VEHICLE RECALL

AMERICAN TRANSPORTATION RECALL # 01306
NHTSA RECALL # 01V- 369

SUBJECT: VEHICLE RECALL
Wiring Diagram Decal Error

Picture showing portion of label on electrical panel door and the area for the new strip placement.

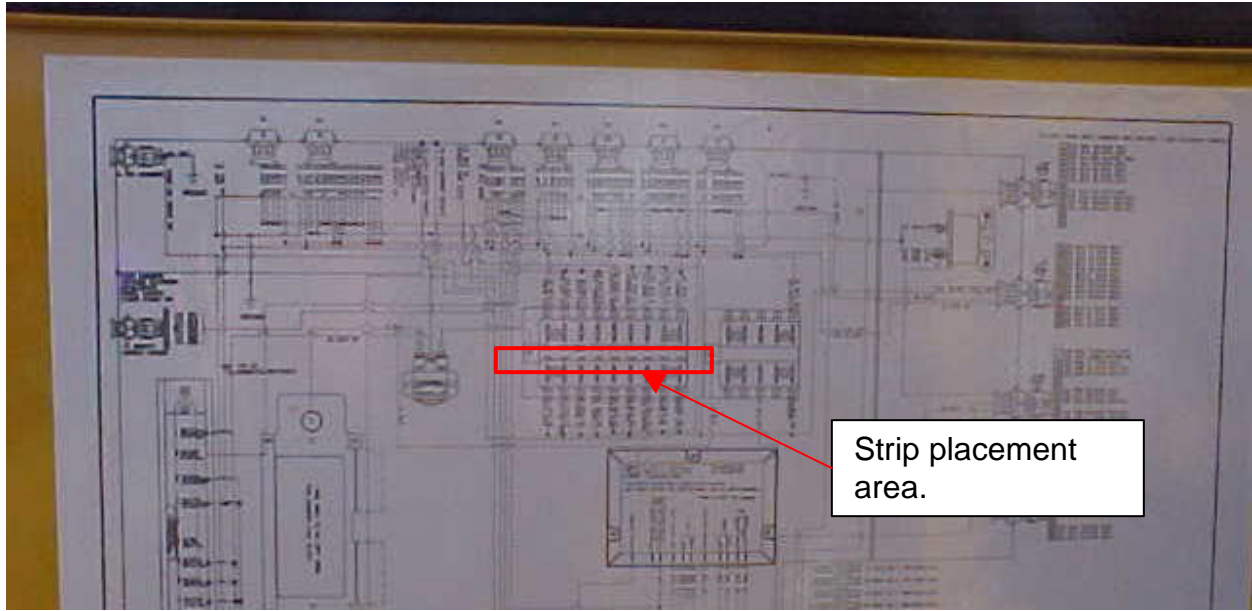
American Transportation Corporation has mailed to the affected customers the following notice. This notice is sent to you in accordance with the requirements of the National Traffic and Motor Vehicle Safety Act. American Transportation Corporation has determined that a defect which relates to motor vehicle safety exist in certain AmTran® FE™ and International® FE buses. The wiring diagram decal located on the electrical access panel door incorrectly displays that the circuit protection size for circuits #7 and #8 is 30 ampere. The correct circuit size should be 20 ampere. The possible change to a higher amperage protection reduces the protection to the electrical components of the heater system. This defect is being considered a **safety issue**. The units were built with the proper size protection in the fuse panel.

The customer was supplied with his notice a strip that must be placed over the incorrect information on the current decal. See repair procedure.

The owner was told that they might make this repair or contact their dealer to perform this repair. The repair procedure requires taking the decal strip supplied with the notice and placing it over the current data on the existing decal. Make sure that the surface is clean and dry. The new strip has a protective back and when removed will stick to the current decal. The new strip shall be aligned to cover the same detail that is on the original decal. See picture below for more detail.
